DIAGRAM # 2

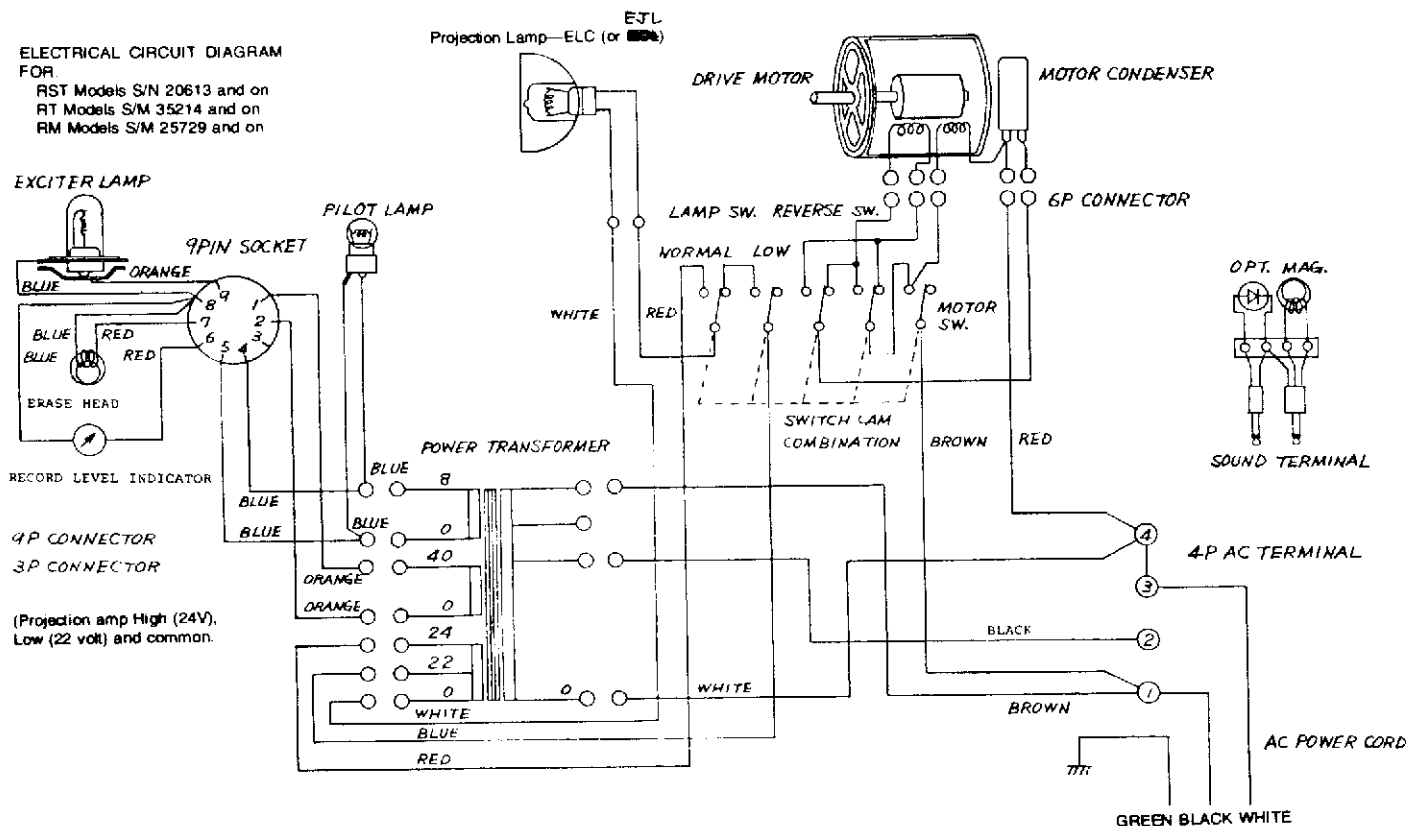
The EIKI R series electrical circuit diagram No. 2 shows two modifications. The 2 amp fuse has been eliminated from the wiring harness and placed on the amplifier chassis. Two plugs are used for the lamp transformer.

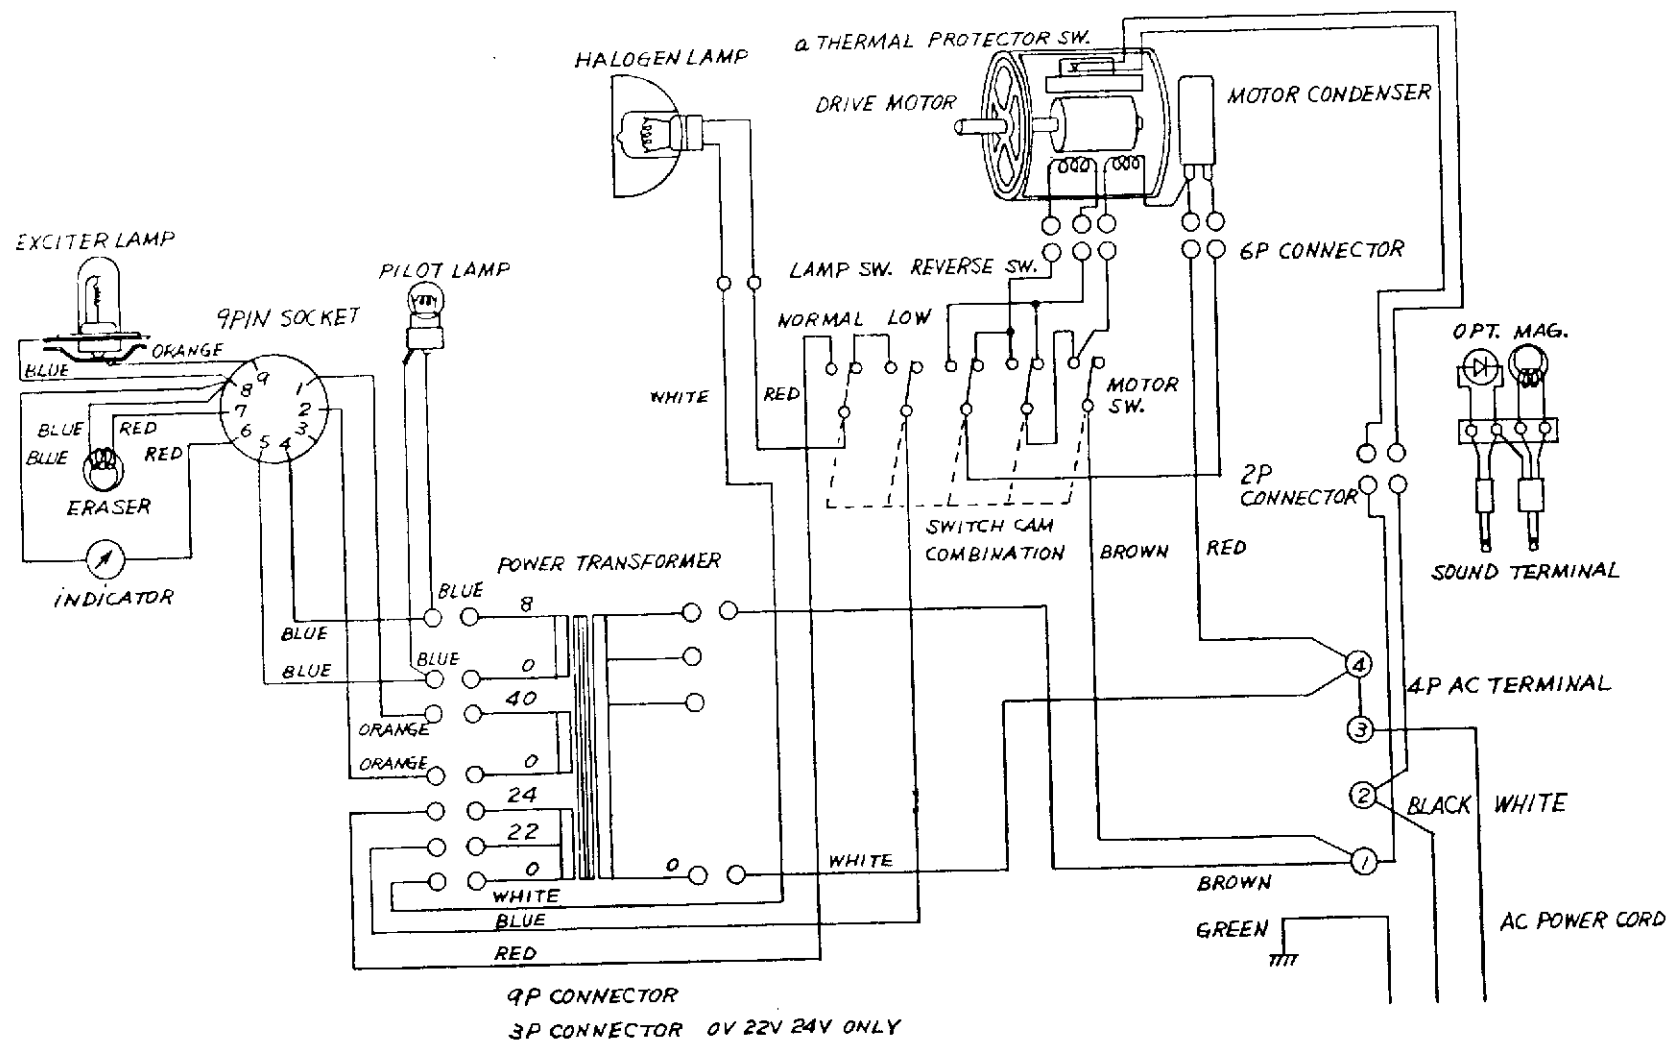
The EIKI R series circuit schematic No. 3 has an added thermal protector switch on the motor circuit.
